**Soil Sampling and Analysis Plan
to Characterize
Individual Hazardous Substance Sites (IHSS)
121 and 148
at Building 123**

SUBJECT REVIEW OF STATISTICAL ADEQUACY OF DRAFT SOIL SAMPLING AND ANALYSIS PLAN TO SUPPORT BUILDING 123 D&D - TRG-015-97

TO Kent Dorr, K-H Project Management, Building T130F, X6034
FROM Doug Steffen, RMRS E/C/D Project Management, Bldg T130F, X2164
DATE August 28, 1997
SUBJECT **Soil Sampling and Analysis Plan to Characterize IHSSs 121 and 148 at Building 123: Response to CDPHE Comments**

**Closure Plan for Building 123
Components of
RCRA Unit 40**

Figure 4 1 Soil Sampling Locations

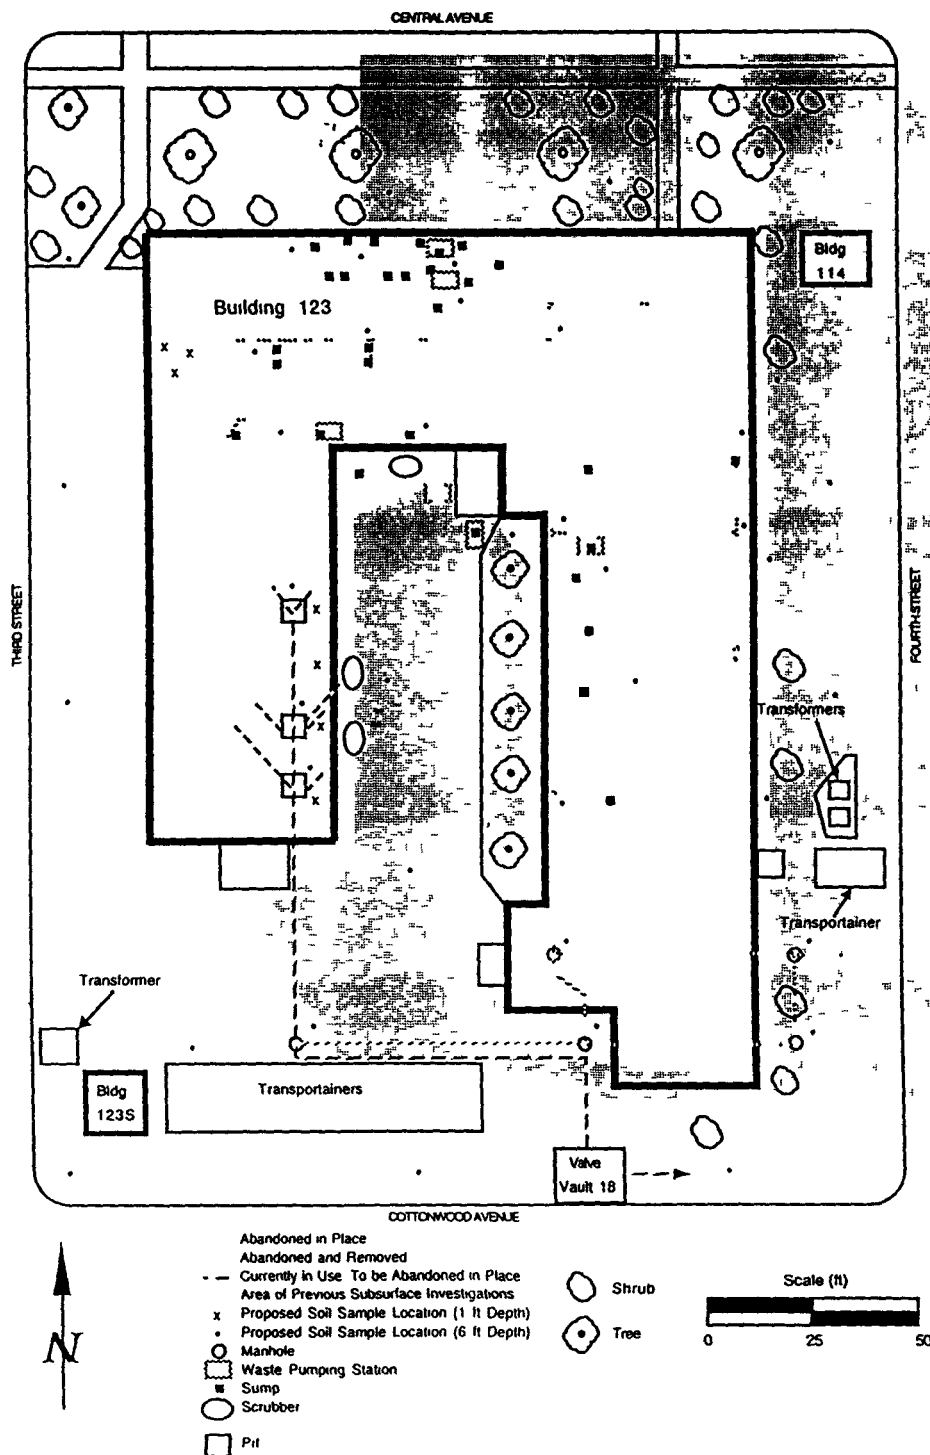
Based upon the locations shown in Figure 4.1 of the proposed sampling plan and assuming they are plotted to scale, it is estimated that any hot spot with a radius of fifteen feet or greater would be detected with approximately ninety-five percent probability. Any hot spot emanating from a sump with a radius of twelve-feet or more or emanating from a PWL point of redirection with a radius of six feet or more would be detected with approximately eighty percent probability. If hot spots of smaller size are anticipated, high detection probabilities can only be achieved by increasing the number of samples and fixing their locations closer to the more isolated potential hot spots.
